AGENDA
ARCHITECTURAL REVIEW BOARD MEETING
Public Meeting Room, Village Hall
Tuesday, March 19, 2019
7:00 p.m.

Subject: Marriott Lincolnshire Resort Master Sign Plans Amendment

Subject: Solar Panel Installation Extra Space Storage - 200 Parkway Drive – CityPark Center

MARRIOTT DRIVE LOCATION
 REFACE EXISTING D/FACE ILLUMINATED DISPLAY
 3/4" = 1'-0"

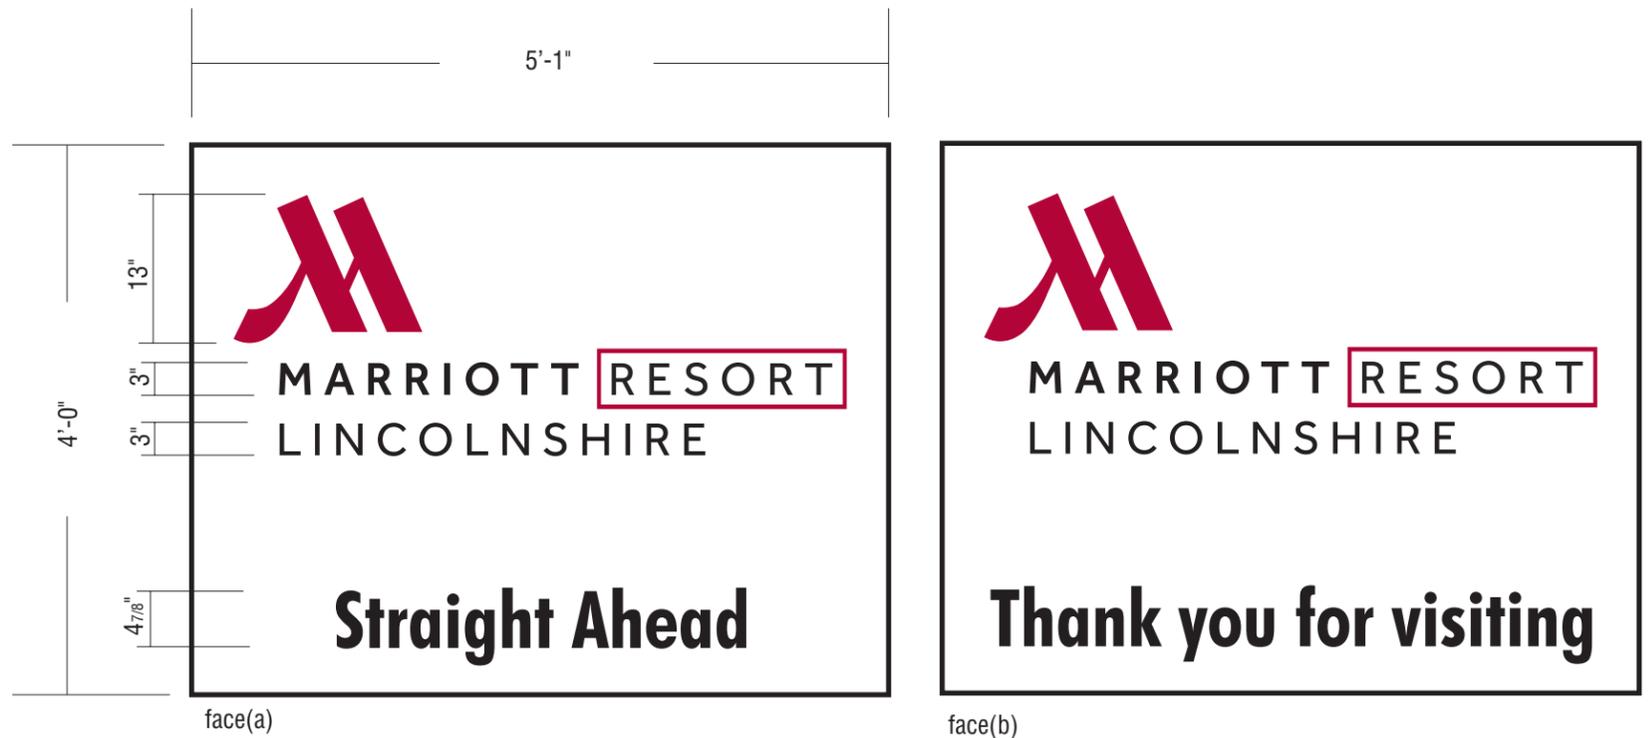
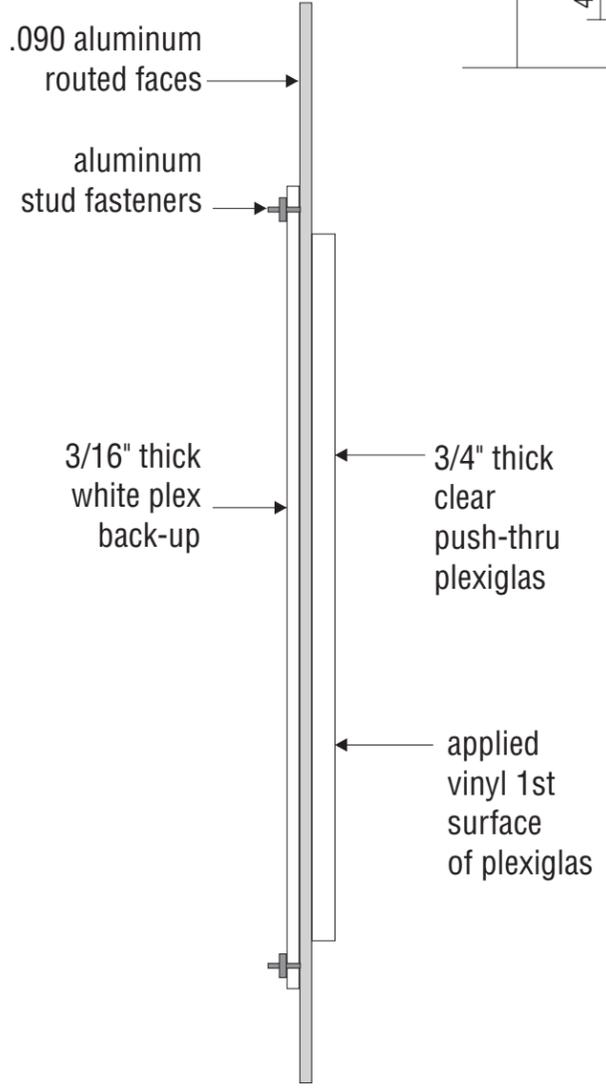
- Directional Sign - One 6'-8" tall by 5'-7" wide double-sided existing directional sign that reads "Thanks for Visiting" and "Straight Ahead" (shown as Directional Sign #1 on the attached Site Plan) is proposed to be repainted white from its current tan color and updated with the new Marriott logo, without altering the sign structure. **Staff requests the ARB's**

FLANGED ALUMINUM PANELS 1-1/2" DEEP
 WHITE FINISH / ROUTED-OUT BACKED-UP WHITE PLEXIGLAS COPY
 3/4" THICK CLEAR PUSH-THRU PLEXIGLAS COPY & LOGO
 TRANSLUCENT RED APPLIED VINYL 1ST SURFACE
 OPAQUE BLACK APPLIED VINYL 1ST SURFACE COPY
 REPAINT EXISTING CABINET WHITE
